SUBJECT: REQUEST FOR ADDITIONAL INFORMATION FOR TOPICAL REPORT
PP901-000-01, REVISION C, "HFC-6000 SAFETY SYSTEM"
(TAC NO. ME7577)

REQUEST FOR ADDITIONAL INFORMATION
FOR SIX OPEN ITEMS OF HF CONTROL CORPORATION
TOPICAL REPORT PP901-000-01, REVISION C, "HFC-6000 SAFETY SYSTEM"
(TAC NO. ME7577)

<i>Figure 1 – EPRI TR 107330 Environment Stress Profile.....</i>	<i>6</i>
<i>Figure 2 – Qualification Test Sequence.....</i>	<i>9</i>
<i>Figure 3 – Component Layout in the Cabinet</i>	<i>11</i>
<i>Figure 4 – Actual Environmental Test Sequences</i>	<i>15</i>

Figure 1 – EPRI TR 107330 Environment Stress Profile

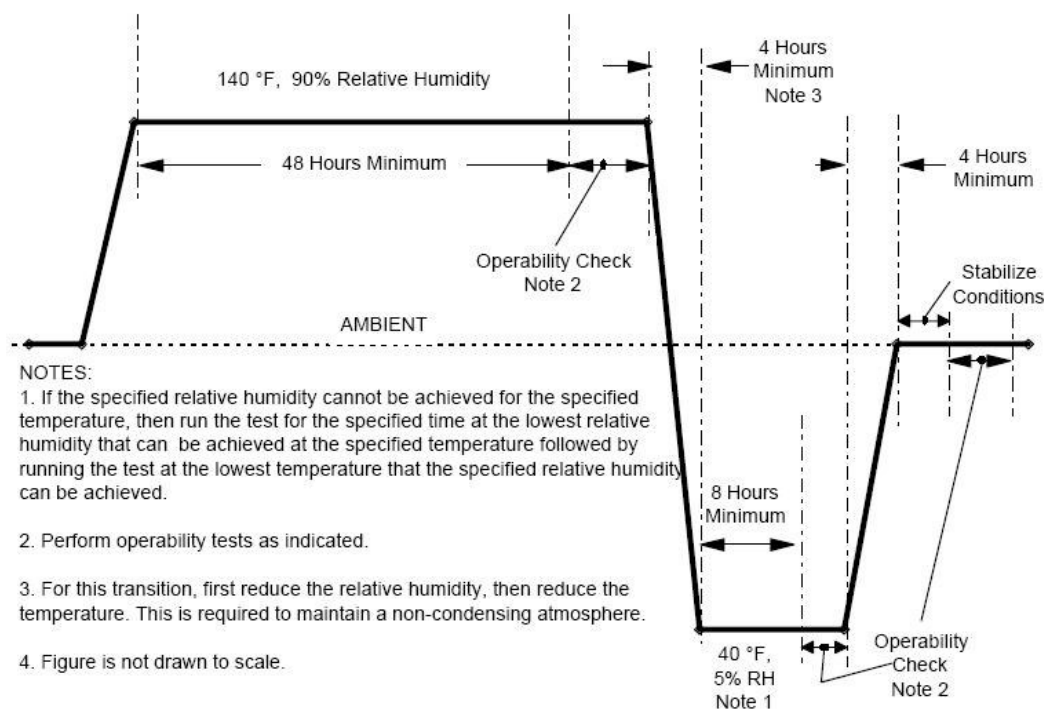
HF Control Corporation (HFC) uses Electric Power Research Institute Topical Report 107330 Figure 4-4 to demonstrate compliance with environment stress requirements as described on page 6 of "Qualification Retest Summary Report," RR901-001-04, ERD111, Rev. A. The figure shows the tests include maintaining 40 °F and 5 percent relative humidity conditions for at least 8 hours. The U.S. Nuclear Regulatory Commission (NRC) staff noted that the test conducted by the Environmental Testing Laboratory (page 5 of Attachment 7.1 of RR901-001-04) only maintained conditions of 4 °C (40 °F) for 4 hours.

Please provide additional testing results or justification for qualification of the HFC-6000 platform under different environmental stress conditions than those conditions defined in EPRI TR-107330.

For environmental stress tests, although there were other profiles applied on the ERD111 test specimen, this report focuses on the EPRI TR 107330 Figure 4-4 compliance test profile, see Figure 1.

Figure 4 – Actual Environmental Test Sequences
(See ETL Lab Report for the detail profile)

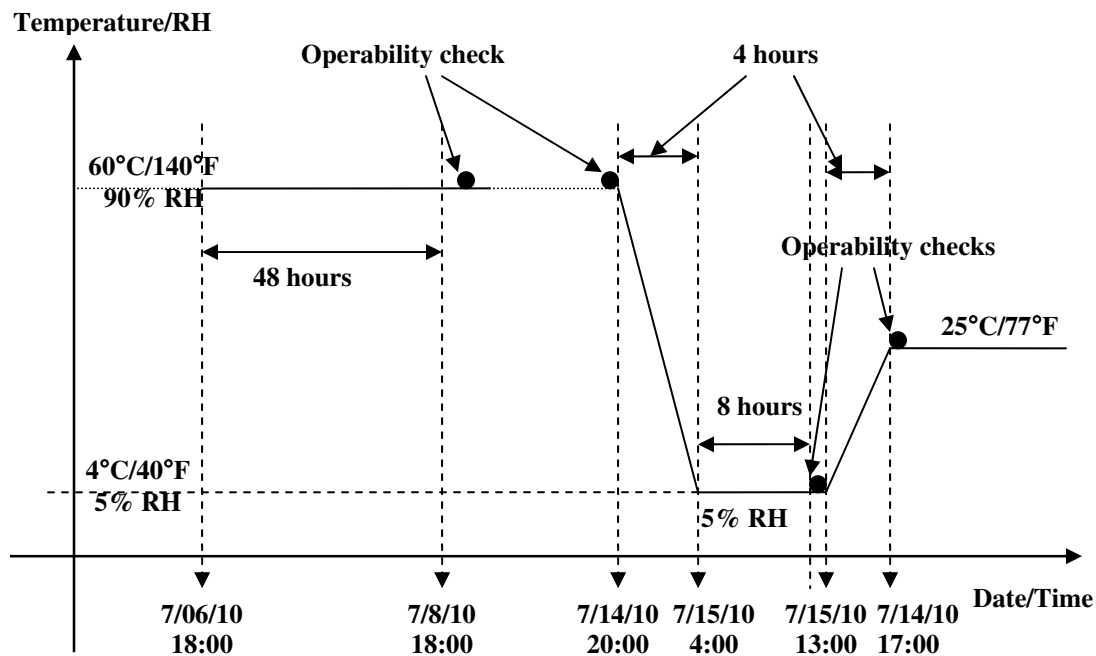
HF Corporation (HFC) uses Electric Power and Research Institute Topical Report 107330 Figure 4-4 to demonstrate compliance with environment stress requirements as described on page 6 of "Qualification Retest Summary Report", RR901-001-04, ERD111 Rev. A. The Figure shows the tests include maintaining 40 °F and 5% relative humidity conditions for at least 8 hours. The staff noted that the test conducted by the Environmental Testing Laboratory (page 5 of Attachment 7.1 of RR901-001-04) only maintained conditions of 4 °C (40 °F) for 4 hours.

During the environment stress retest, the time of exposure of the ERD111 test specimen to the high temperature/high humidity (HT/HH) was longer than 48 hours. The first set of operability tests not related to power supplies were performed after the initial exposure of 48 hours. In order not to disrupt the operations, operability tests related to power supplies and power quality were performed at the end of HT/HH exposure before ramping down to low temperature/low humidity. A set of prudency tests were also performed during the first operability checkpoint at the end of the initial 48 hours exposure of HT/HH. No anomalies for the ERD111 test specimen were found at any operability checkpoints.

Figure 1 – CS114 calibration limits

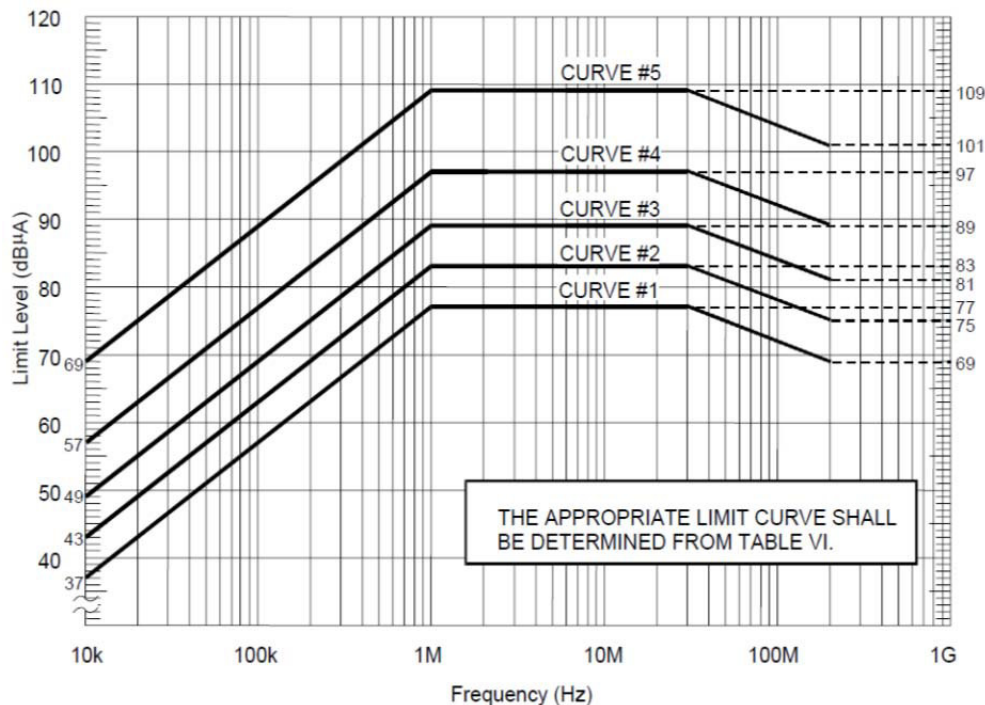
Section 4.2.2 of TR901-200-04, Rev. A (Reference 10), contains the CS114 test results. The NRC staff noted that the CS114 test signal limit values were lower than the values in Figure 4.2 in RG 1.180. In letter dated April 11, 2014 (Reference 3), the NRC staff requested additional information to clarify the lower signal values used in the test. In a letter dated April 30, 2014 (Reference 5), HFC responded that due to the limitation of test equipment at the Nemko USA laboratory, the calibrated test signals could not reach the signals as depicted in Figure 4.2 in RG 1.180.

Due to the limitation of test equipment at Nemko laboratory, the calibrated test signals could not reach the signals as depicted in figure 4.2 in RG 1.180 Rev. 1. HFC could only use the limit curve number #3 for the CS114 tests as specified in MIL-STD-461E. See the following figure as extracted from MIL-STD-461E figure CS114-1.
